Title - Sujet Réfection Bastion St-Louis		
Solicitation No. - N° de l'invitation EE520-173040/A		Amendment No. - N° modif. 001
Client Reference No. - N° de référence du client EE520-173040		Date 2017-03-28
GETS Reference No. - N° de référence de SEAG PW-\$QCM-032-17069		
File No. - N° de dossier QCM-6-39372 (032)	CCC No./N° CCC - FMS No./N° VME	
Solicitation Closes - L'invitation prend fin at - à 02:00 PM on - le 2017-04-06		Time Zone Fuseau horaire Heure Avancée de l'Est HAE
F.O.B. - F.A.B. Plant-Usine: <input type="checkbox"/> Destination: <input checked="" type="checkbox"/> Other-Autre: <input type="checkbox"/>		
Address Enquiries to: - Adresser toutes questions à: Girard, Isabelle		Buyer Id - Id de l'acheteur qcm032
Telephone No. - N° de téléphone (418) 649-2847 ()		FAX No. - N° de FAX (418) 648-2209
Destination - of Goods, Services, and Construction: Destination - des biens, services et construction: Bastion St-Louis, Ville de Québec

AMENDMENT 001

TITLE : Rehabilitation of the right and left sides of the Saint-Louis Bastion

Project n° : R.081006.001 (TPSGC)
Project : Restoration of Bastion St-Louis, Right & Left face
Date : 2017-03-27

ADDENDA / ADDENDUM no, 1 - S01
DE / FROM PAGE S06
2017-03-24

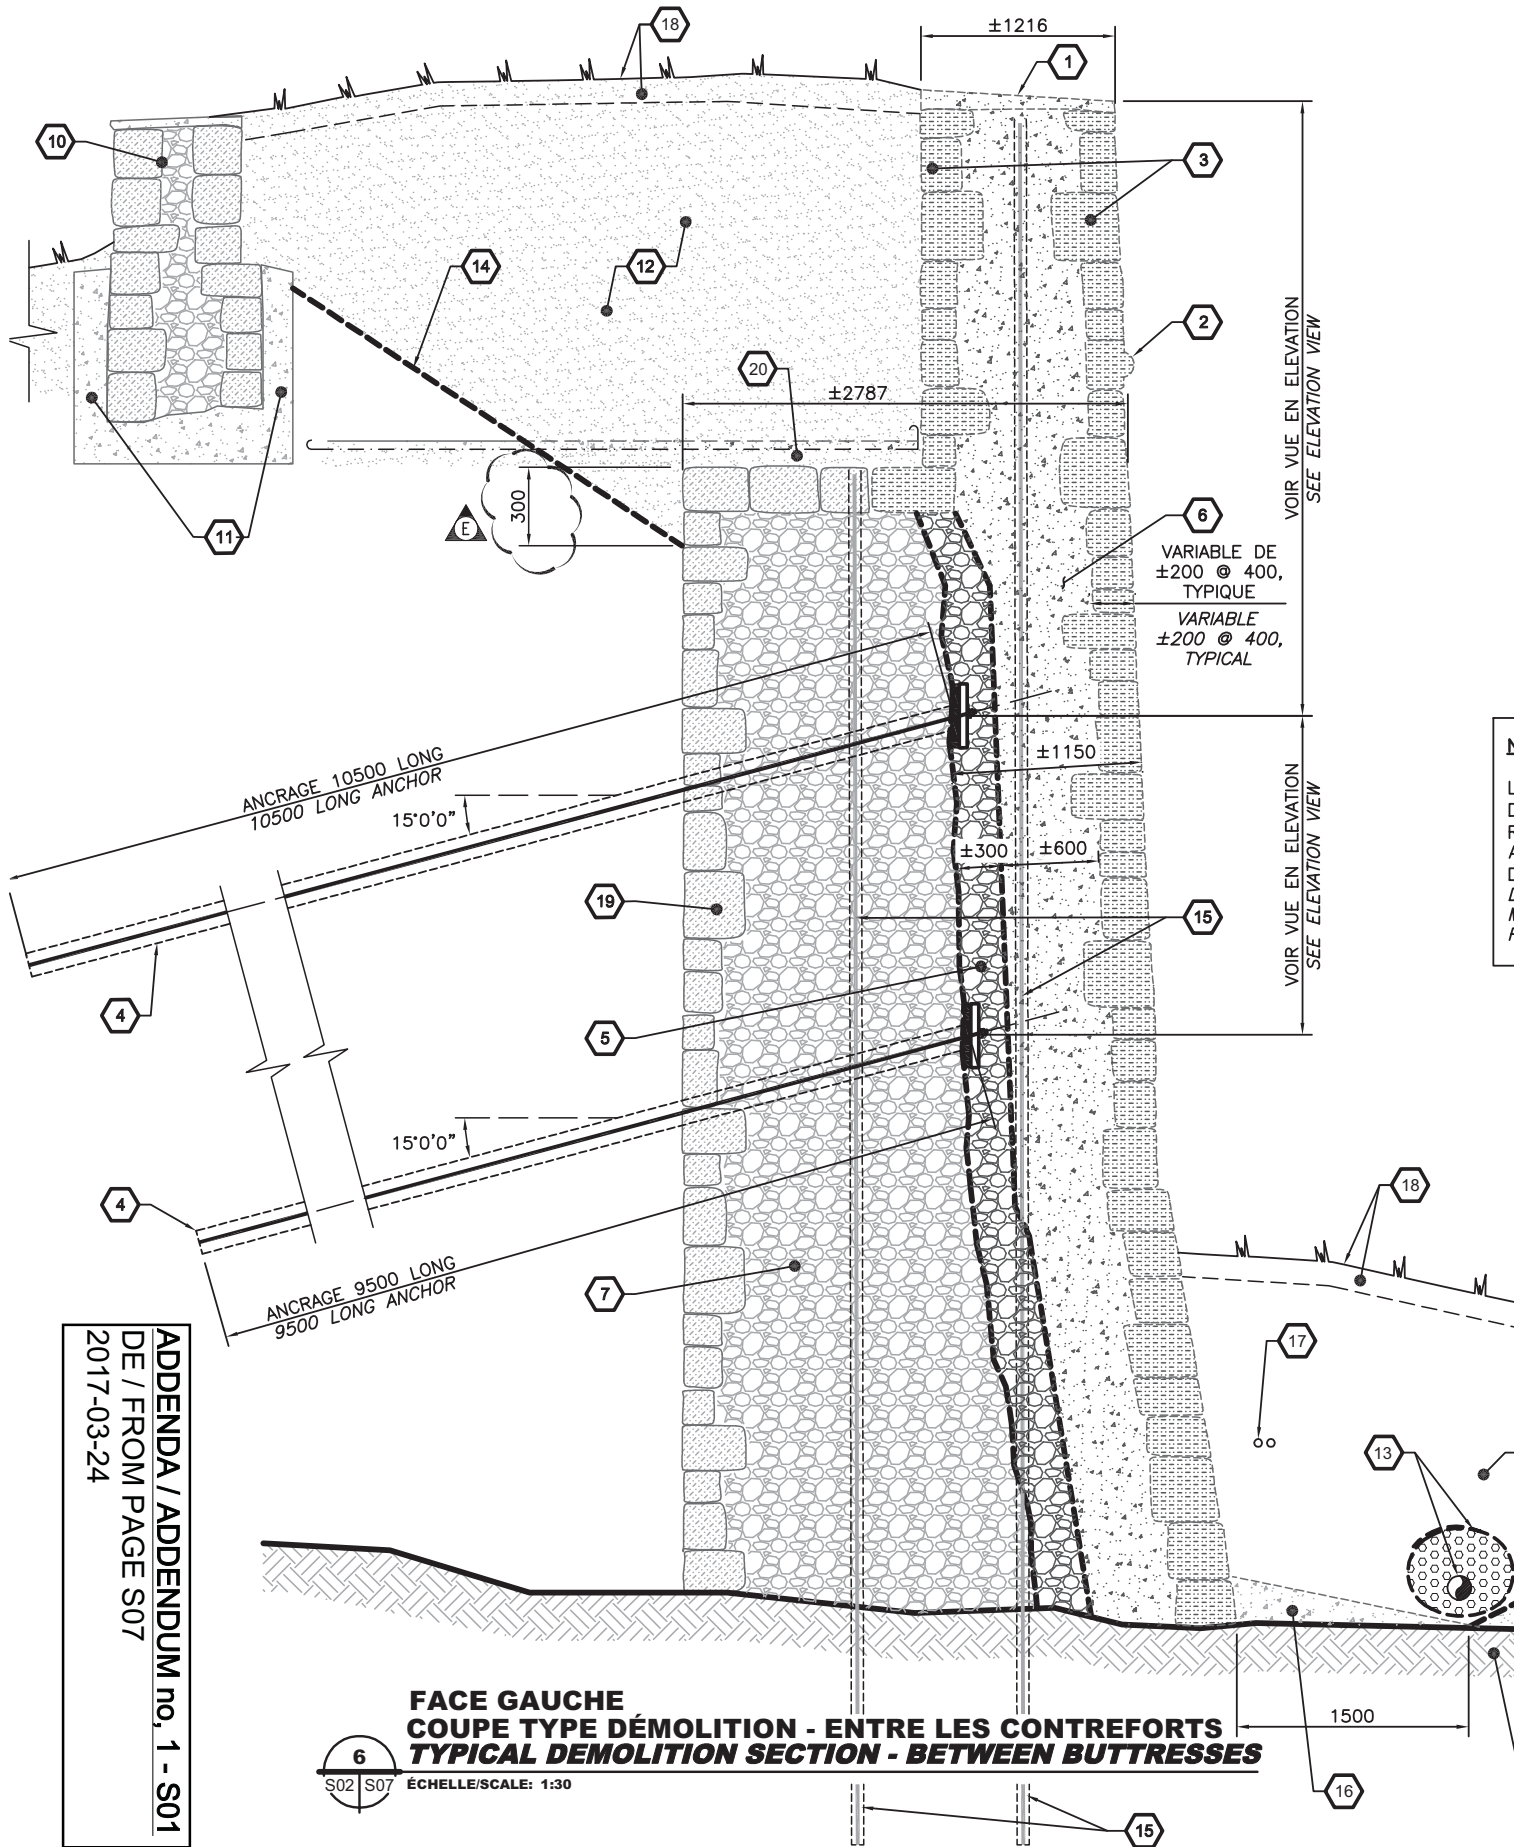
S-06 Une mauvaise traduction est corrigée au chainage 5 (voir croquis).
Correction of a bad translation at chainage 5 (see sketch).

ADDENDA / ADDENDUM no. 1 - S01
DE / FROM PAGE S07
2017-03-24

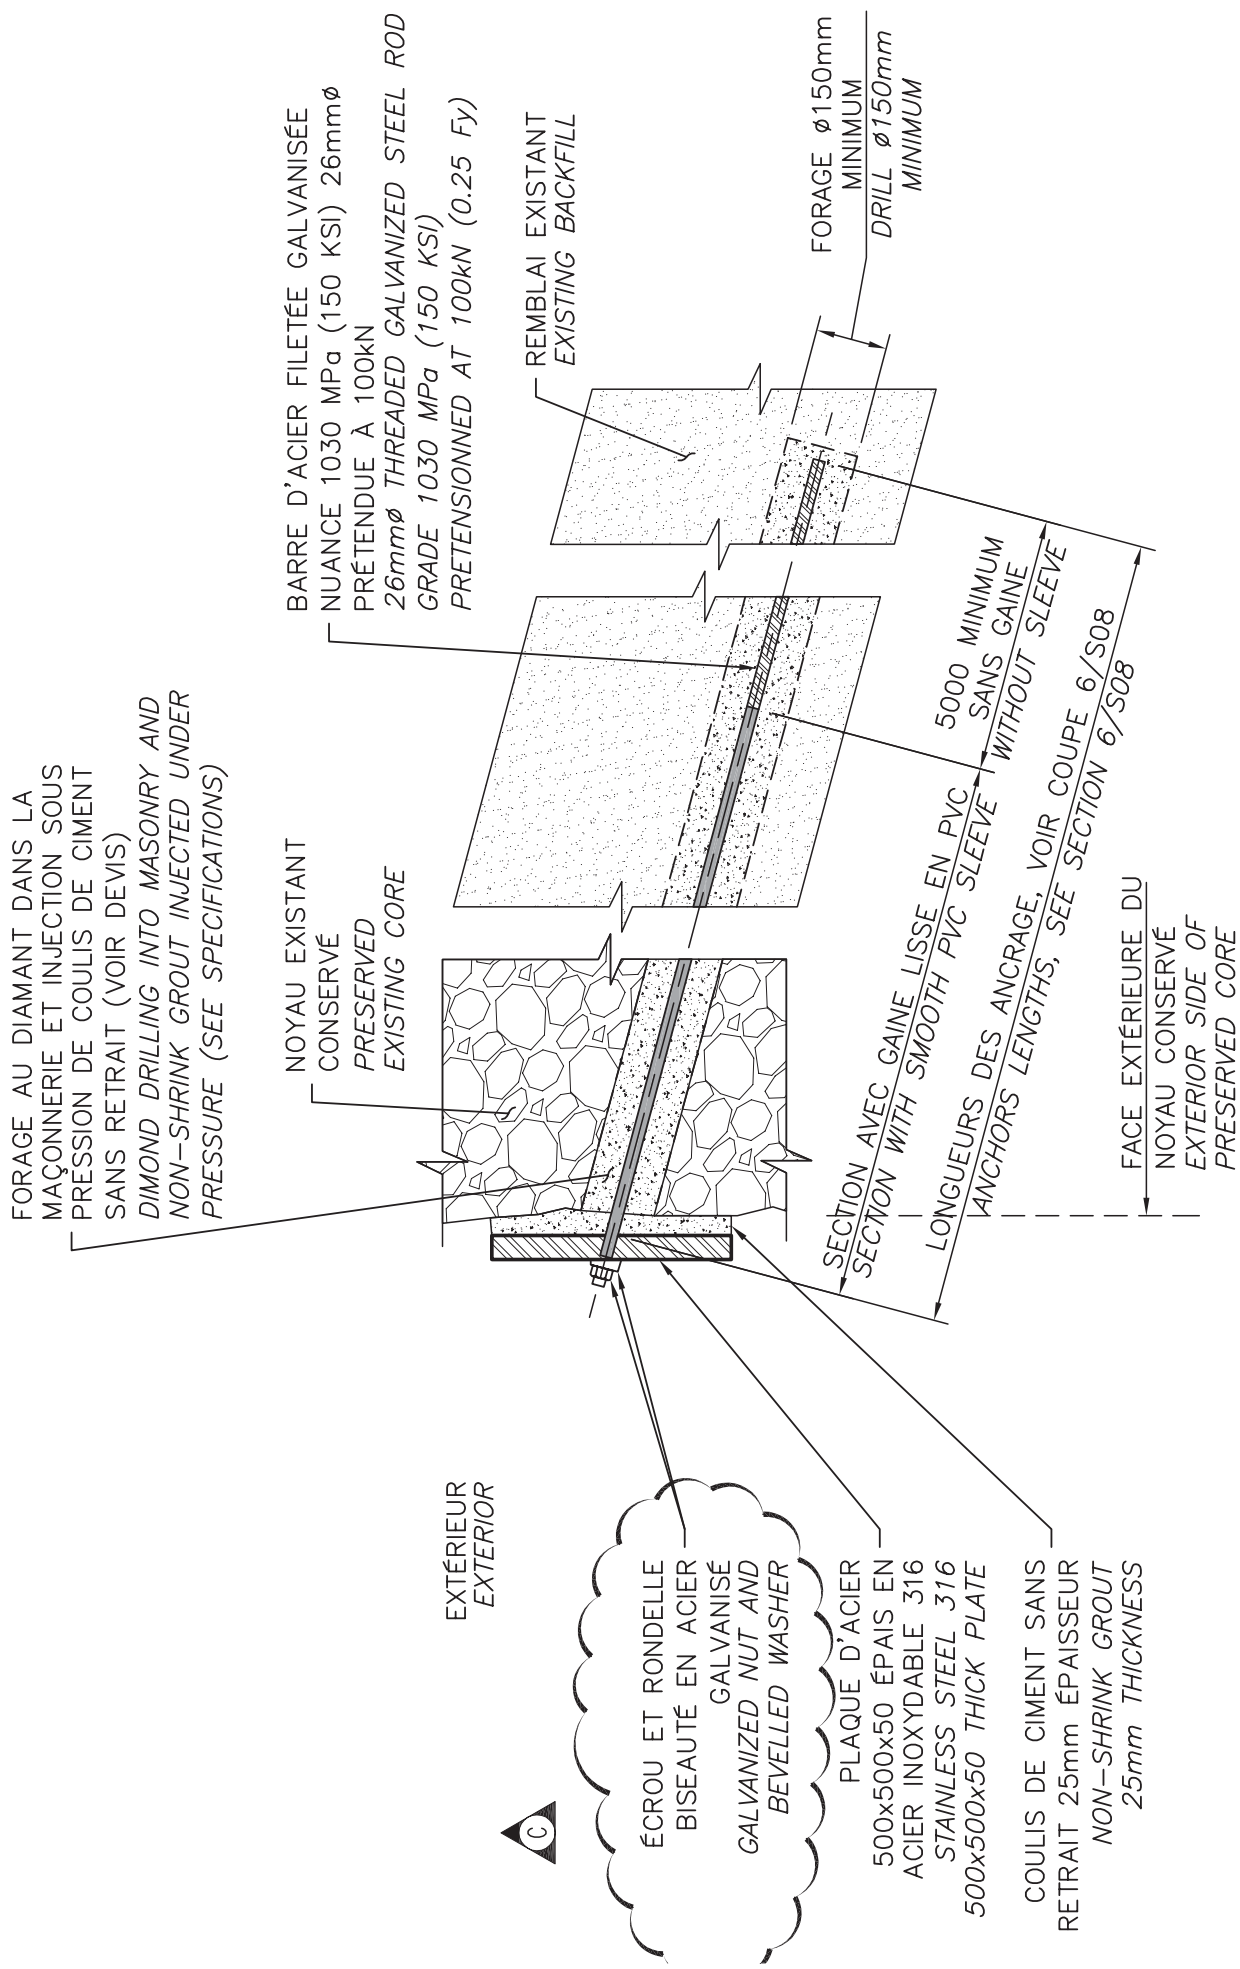
S-07 La limite d'excavation est corrigée à la coupe 7 (voir croquis).
Correction of excavation section in section 7 (see sketch).

DÉTAIL D'ANCRAGES À SOL (FACE GAUCHE SEULEMENT BACKFILL ANCHOR DETAIL (LEFT FACE ONLY))

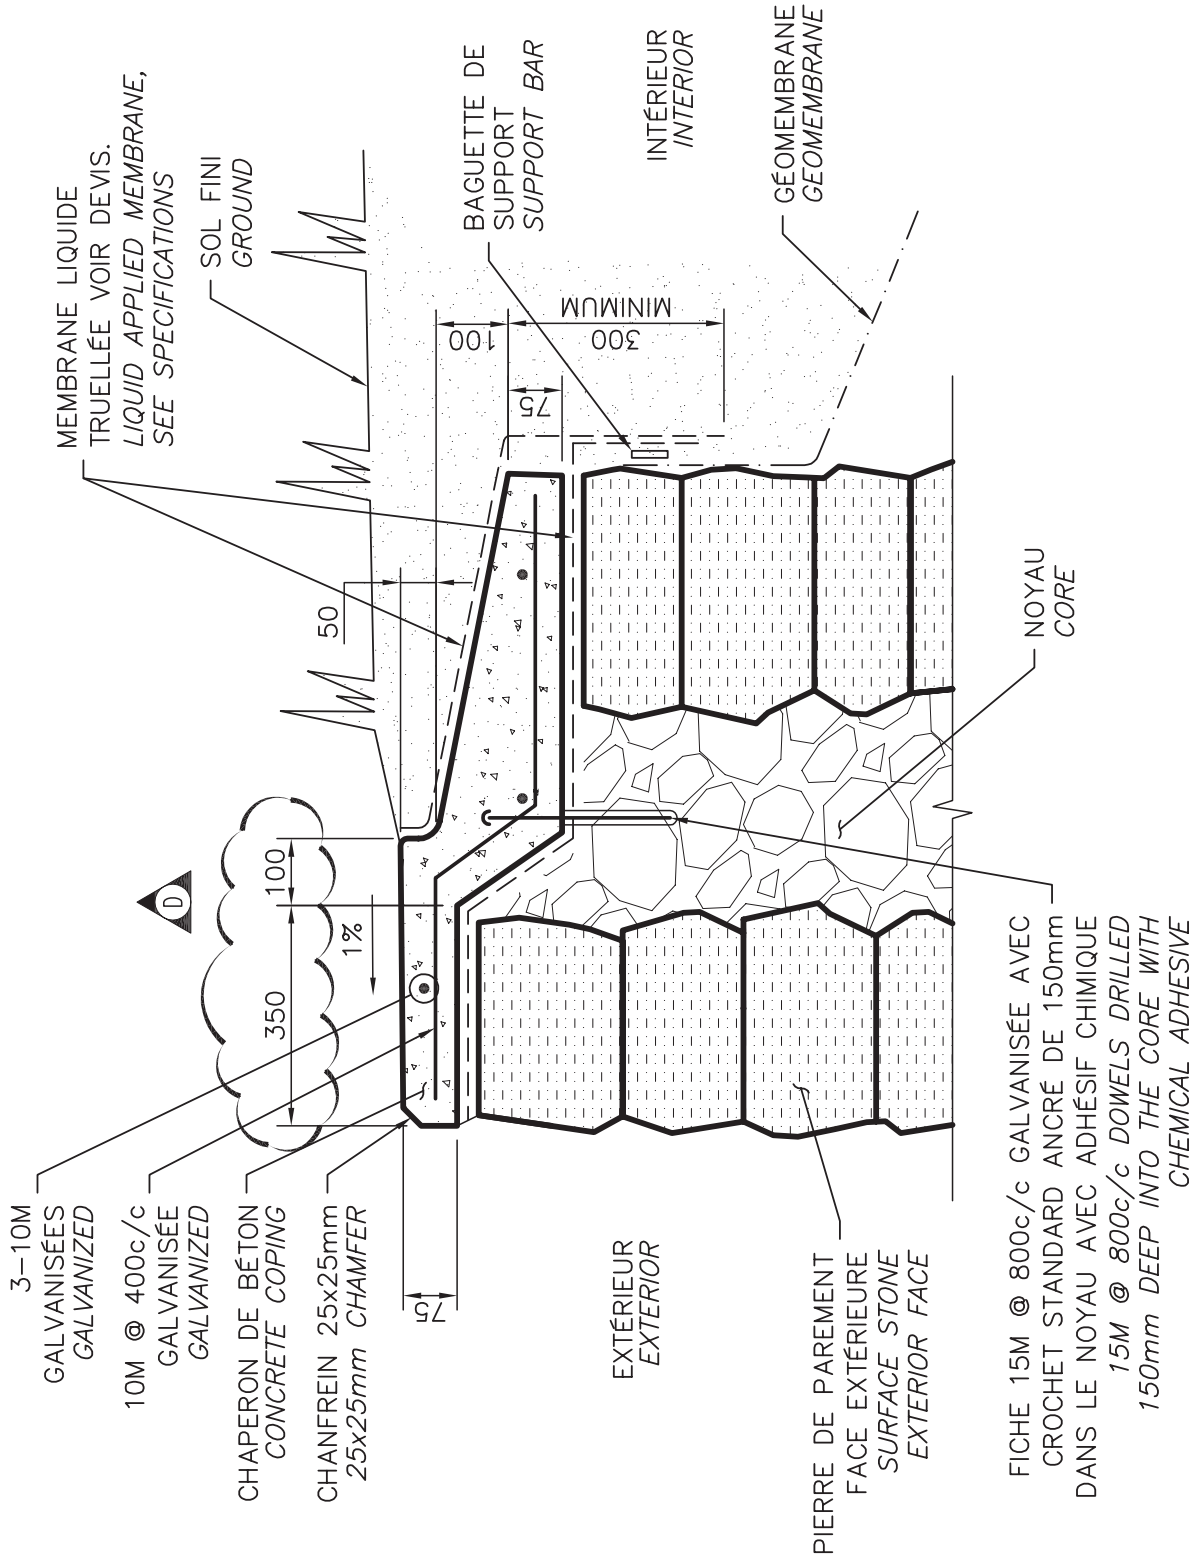
Question 7: Details on soil anchors – According to our suppliers, the stainless steel bolts and washers are not compatible with the galvanized steel rods. Is this correct?

- S-10 Détail d'ancrage à sol (face gauche seulement) : L'écrou et la rondelle biseautée doivent être galvanisés (voir croquis).
Backfill anchor detail (Left face only): Nut and bevelled washer shall be galvanized (see sketch).

Response 7: The bolts and the tapered washers may be made of galvanized steel.
